# **Final Environmental Impact Statement**

## **Master Plan for the National Memorial Cemetery of the Pacific, Honolulu, Hawaii**

FINAL ENVIRONMENTAL IMPACT STATEMENT  
FOR THE  
NATIONAL MEMORIAL CEMETERY OF THE  
PACIFIC, HONOLULU, HAWAII

This report consists of a reprint of the Revised Draft Environmental Impact Statement along with responses received from Federal, State, and local agencies and other interested parties. The entire report constitutes the Final Environmental Impact Statement.

FIGURE 1.1  
PROPOSED MASTER PLAN

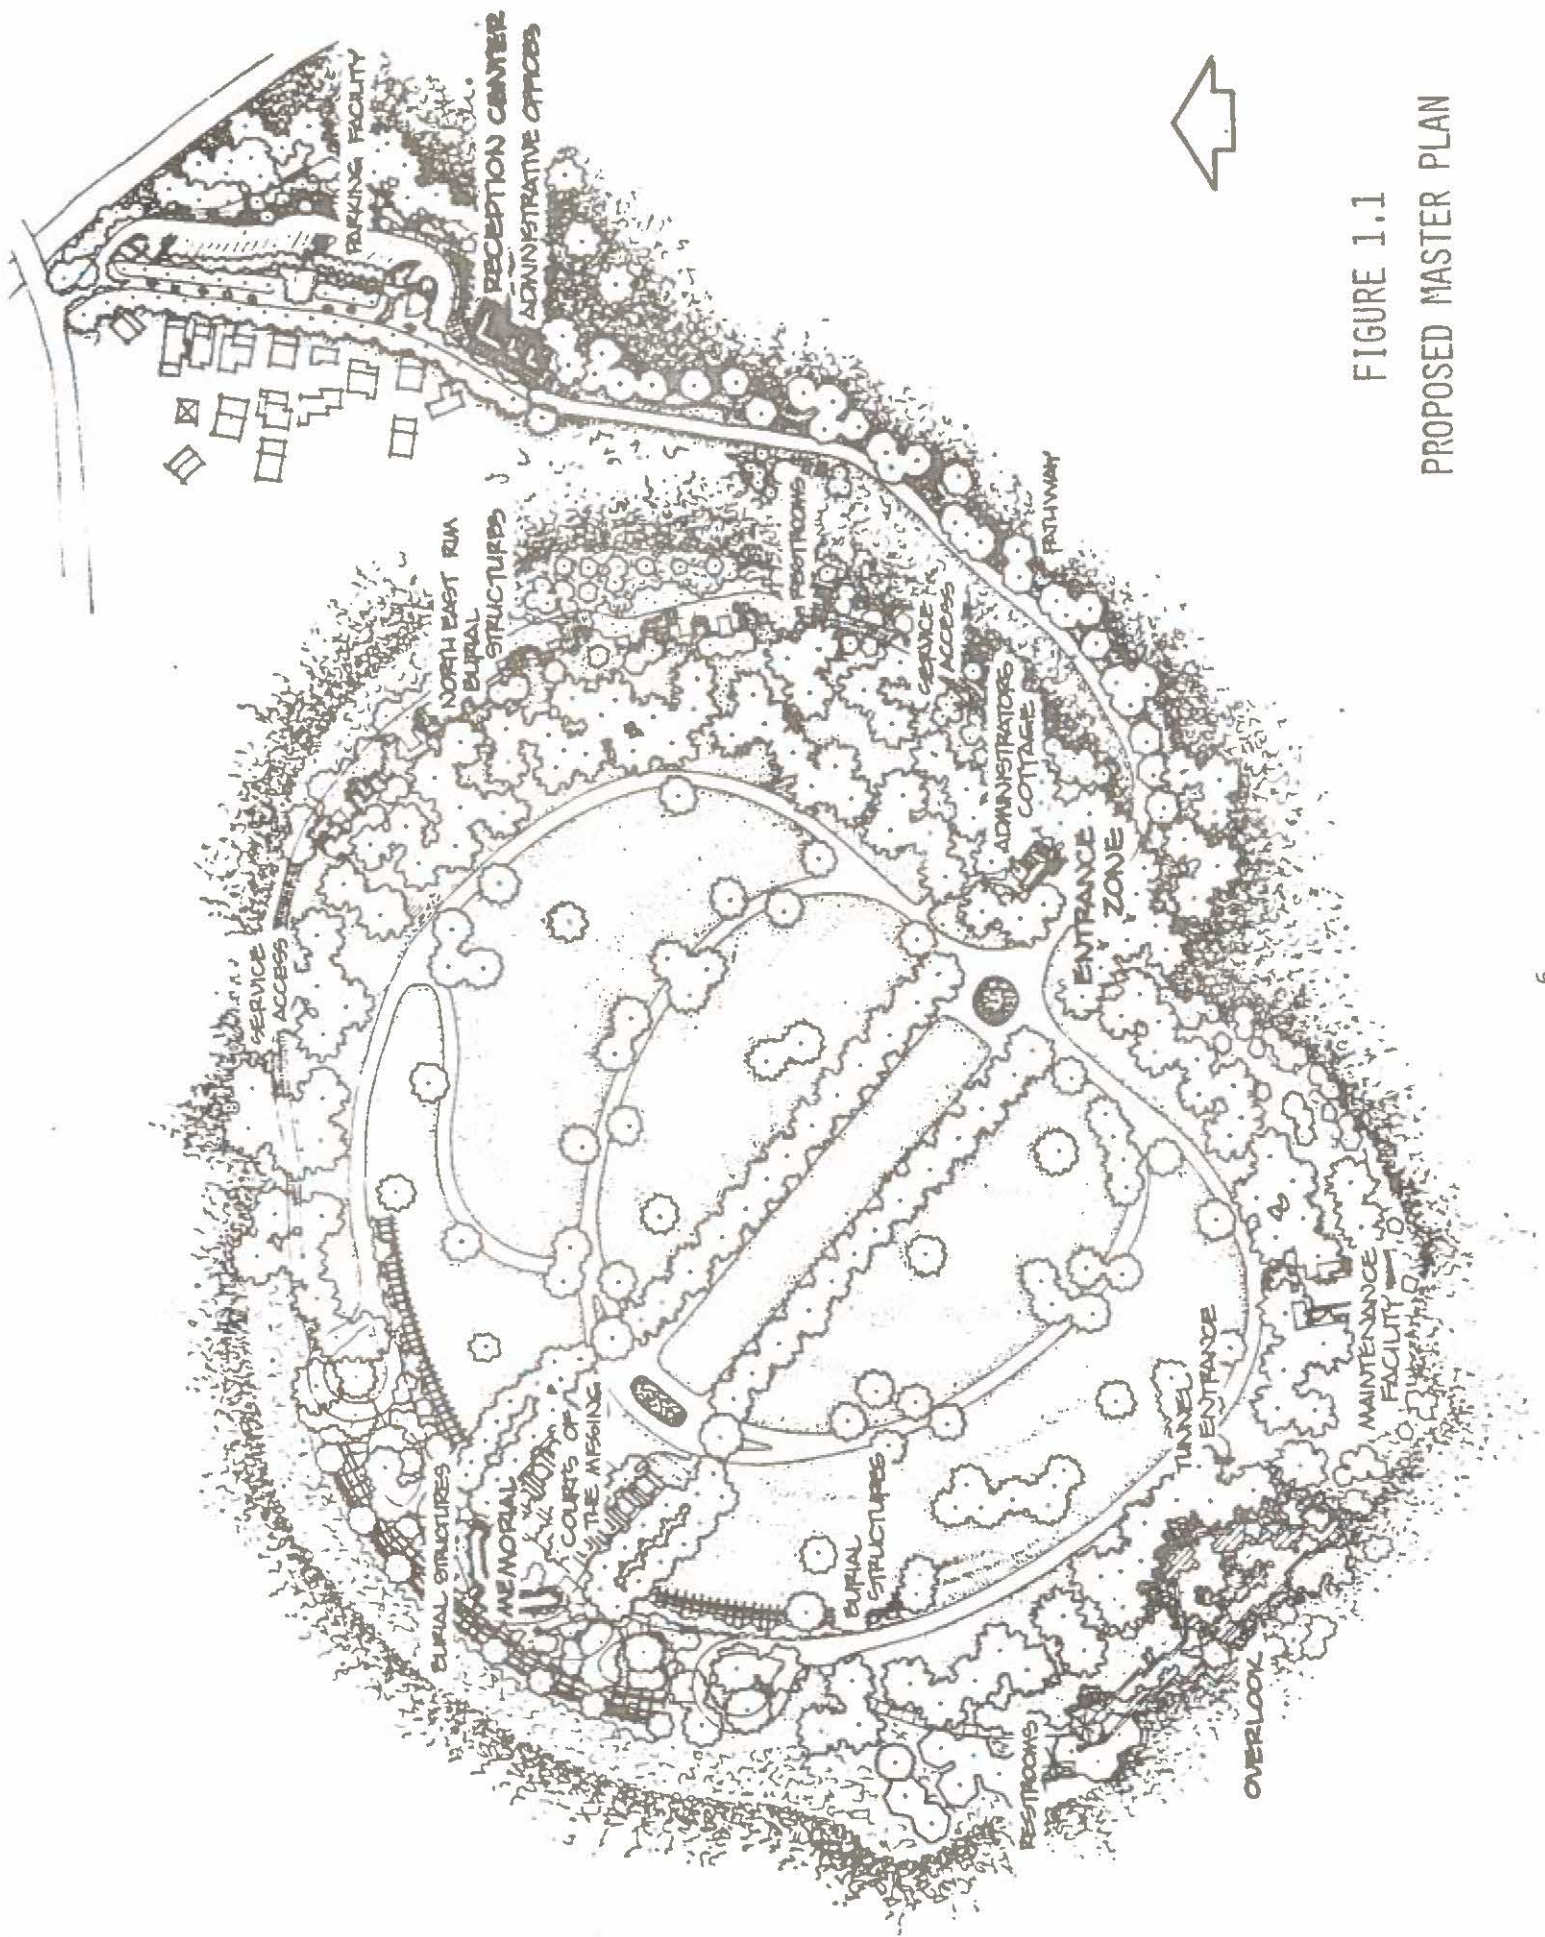
The Environmental Center has reviewed the above cited Revised DEIS. We are pleased to note management strategies to control traffic will be utilized rather than the now deleted proposed parking structure. This should significantly reduce potential environmental impacts of the proposed project.

crater slopes." Will indication of the scale of the proposed parking facilities be provided in the Final EIS? Will the parking include any bus parking so that visitors touring the crater by bus will be able to take advantage of the facilities the visitor administration center will provide?

The Revised DEIS states on page 11, sec 1.2.2C that the crater overlook area will be reconstructed. Could it be clarified as to how a new rock wall and trees will improve access and reduce traffic?

Will the Final EIS provide further information on the proposed visitor/administration center? No indication is given as to the size, location, scope, function, and design of the proposed facility. Such information would be very helpful in evaluating the environmental impacts of the project.

RESPONSE: At this time the VA is not proposing to regulate traffic other than tour buses. On specific days of extremely heavy visitation that may disrupt interment services, the VA will take steps to regulate traffic.

RESPONSE: Comment noted. At this time there are no plans of the limited scale administration building and its support parking. Also the Overlook will be redesigned as traffic must be accommodated. It had been proposed to eliminate traffic from this area and service it with the mini-train (bus) system. No design solutions exist at this time, but great care will be taken to design and implement a project to protect and enhance the visual setting, the natural environment and the public health, welfare, and safety.
